## *City of El Paso – City Plan Commission Staff Report*

**Case No:** SUSU11-00126 Lomas Del Este Subdivision  
**Application Type:** Major Final  
**CPC Hearing Date:** January 5, 2012  
**Staff Planner:** Raul Garcia, 915-541-4935, [garcia1@elpasotexas.gov](mailto:garcia1@elpasotexas.gov)  
**Location:** East of Zaragoza Road and North of Edgemere Boulevard  
**Acreage:** 168.97 acres  
**Rep District:** 5  
**Existing Use:** Vacant  
**Existing Zoning:** R-5 (Residential) and C-4/c (Commercial/condition)  
**Proposed Zoning:** R-5 (Residential) and C-4/c (Commercial/condition)  
**Nearest School:** Chester E. Jordan Elementary School (0.65 mile)  
**Nearest Park:** Tim Foster Park (0.37 mile)  
**Park Fees:** \$54,280  
**Impact Fee Area:** Not in Impact Fee Area  
**Property Owner:** Ranchos Real XIV, River Oaks Properties  
**Applicant:** Ranchos Real XIV, River Oaks Properties  
**Representative:** SLI Engineering, Inc.

**ATTACHMENT 4**

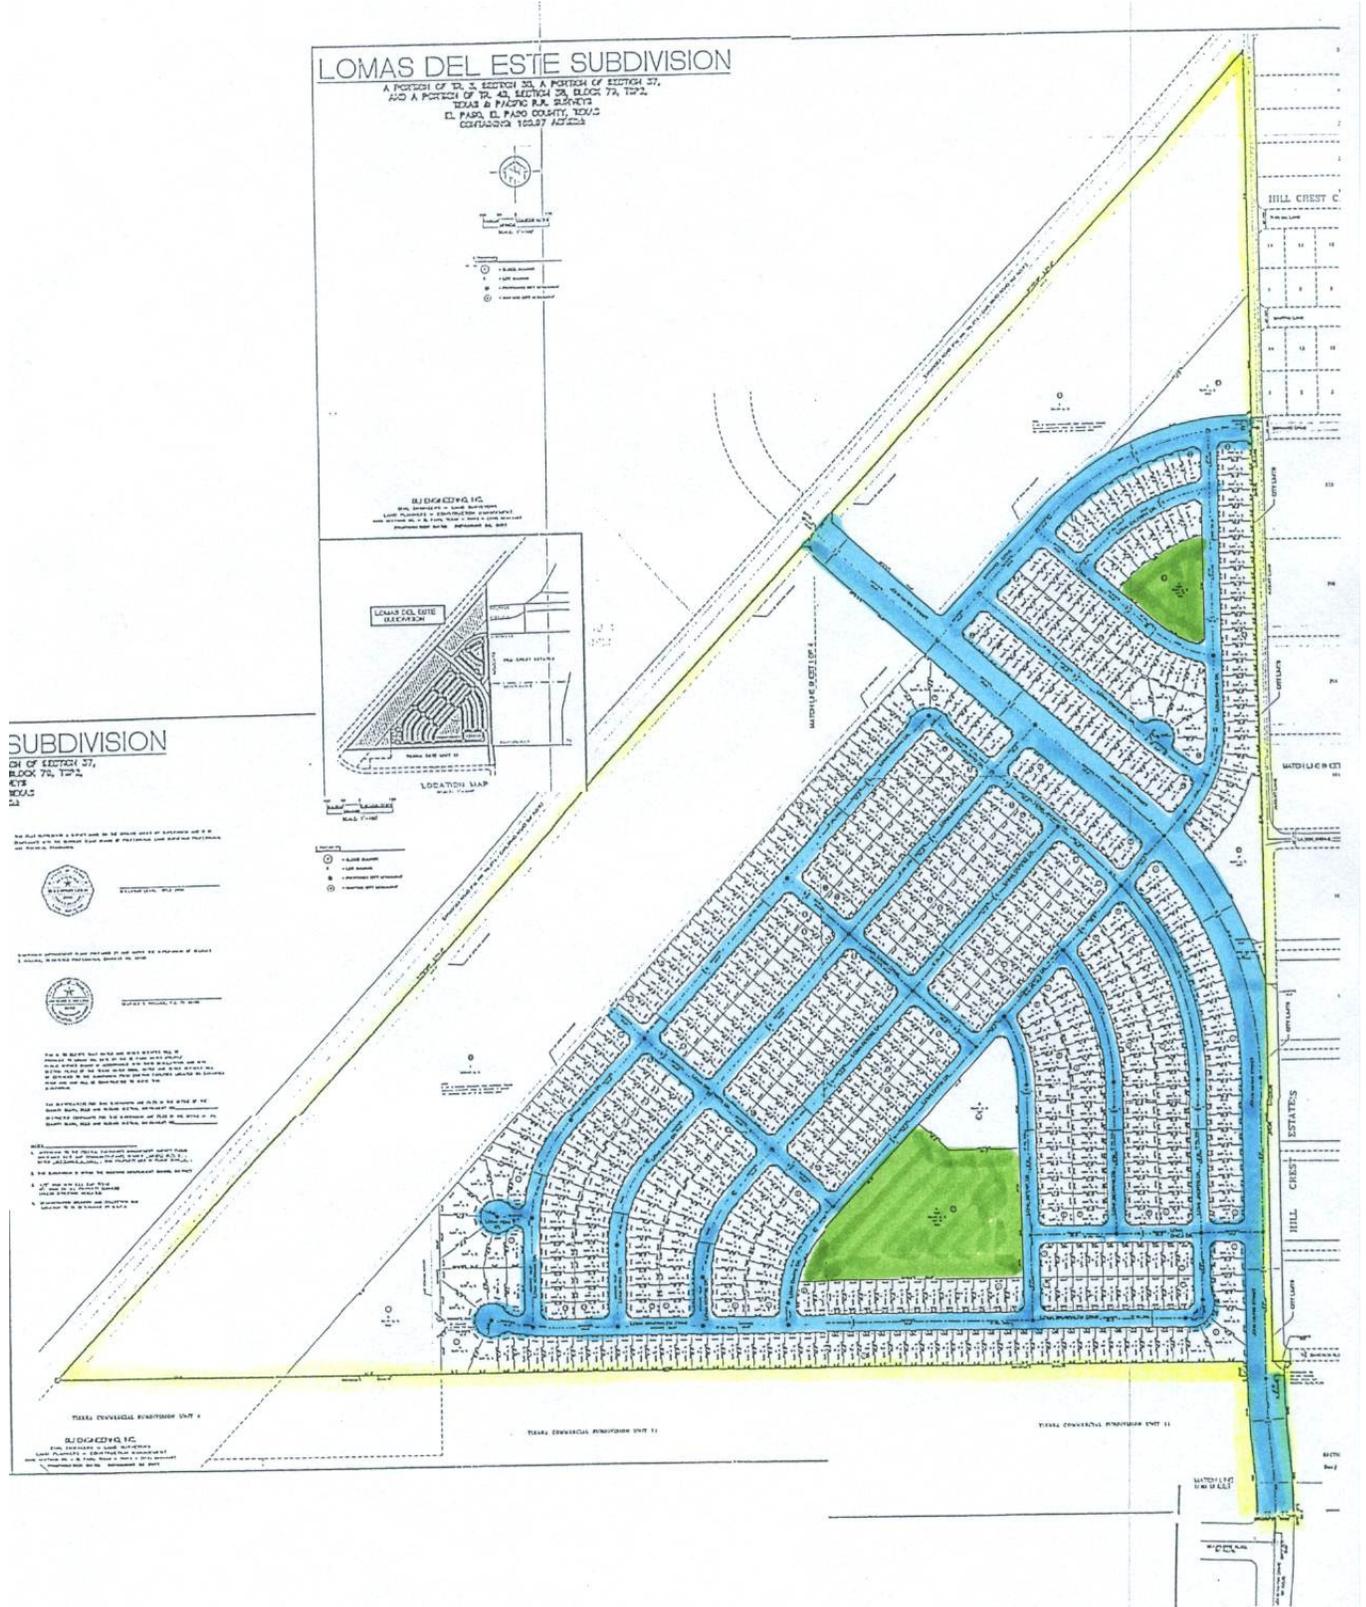
We have reviewed Lomas Del Este Subdivision, a major final plat map and offer Applicant / Developer the following comments:

1. Clarify if addresses as noted for both parks are along Loma Dante Dr.

Off-site easements for sanitary sewer main extensions will be required immediately south of the Pond identified as Lot 78, Block 1, Lomas Del Este Subdivision to enable connection into the existing sanitary sewer main located along Edgemere Boulevard.

2. A portion of the pond located on John Hayes Drive was shown outside the City of El Paso boundary on the previous preliminary plat. Provide a timetable for the proposed annexation of this property to the City of El Paso. The EPWU Stormwater Utility will not accept maintenance of the pond until the annexation is complete.
